Access Compliance Report

Public Rights-of-Way

(Curb Ramps)

Intersection ID: 49382	Main Street: SOUTH_DEVON_ST	Cross Street: ROCKY_RIVER_RD	Location: SE
ADA ID: 77C31D1EC4D1	Ramp Type: Perp	Initial Pass/Fail: Fail	Overall Compliance: No
		Severity Score: 12.5

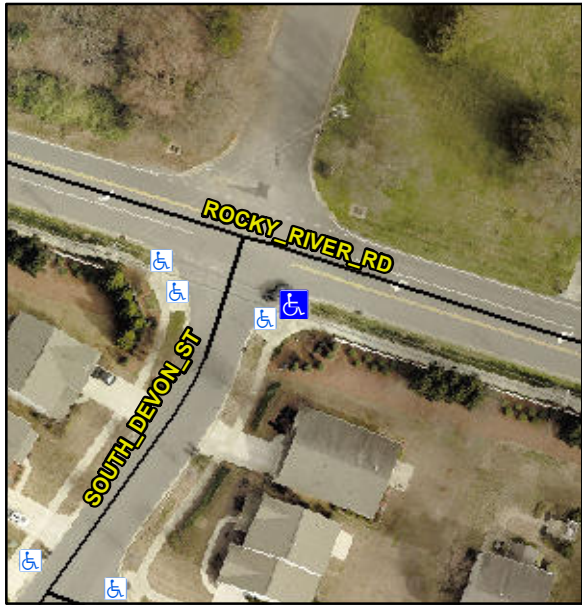
Codes/Mitigation Info/Possible Solution			Field Measurements/Component Compliance					
	Possible Solutions:		Compliance	Description	Data	Compliance	Description	Data
	Remove & Replace Entire Ramp.		N/A	Ramp Length (in)	94.5	No	Ramp Slope (%)	8.8
			Yes	Ramp Width (in)	48.0	Yes	Ramp XSlope (%)	0.6
			N/A	Flare Type LT	N/A	N/A	Flare Type RT	N/A
			N/A	Flare Slope LT (%)	N/A	N/A	Flare Slope RT (%)	N/A
			N/A	Flare Traversable LT?	N/A	N/A	Flare Traversable RT?	N/A
			N/A	Landing Length (in)	N/A	N/A	DWS Provided?	N/A
			N/A	Landing Width (in)	N/A	N/A	DWS Contrast?	N/A
			N/A	Landing Slope (%)	N/A	N/A	DWS Length (in)	N/A
			N/A	Landing X Slope (%)	N/A	N/A	DWS Full Width?	N/A
<p>Surveyor Notes:</p> <p>N/A</p> <p>PROW/ADA:</p> <p>Not Found, R304.2.2</p>			N/A	Landing Curb? (Y/N)	N/A	N/A	DWS Offset (in)	N/A
			N/A	Shared Landing?	N/A			
			N/A	Gutter Ponding?	N/A	N/A	Gutter Slope (%)	N/A
			N/A	Gutter Lip Ht (in)	N/A	N/A	Gutter X Slope (%)	N/A

N/A	Painted X Walk1?	No	N/A	Painted X Walk2?	N/A
				X Walk 1 Direction	To NE		X Walk 2 Direction	N/A
			N/A	X Walk 1 Width (in)	N/A	N/A	X Walk 2 Width (in)	N/A
				X Walk 1 Slope (%)	1.0		X Walk 2 Slope (%)	N/A
				X Walk 1 X Slope (%)	0.4		X Walk 2 X Slope (%)	N/A
			N/A	Ramp inside XWalk1?	N/A	N/A	Ramp inside XWalk2?	N/A
			Road Slope (%)	0.4	N/A	Clear Space?	N/A	
			Road X Slope (%)	1.0	N/A	Clear Space to XWalk (in)	N/A	
		N/A	Any Obstructions?	N/A	N/A	Storm Grate/Utility Hazard?	N/A	
			Obstruction Type			Storm Grate/Utility Type		
					N/A			N/A
						Yes	Surface Condition? (G/P)	Good
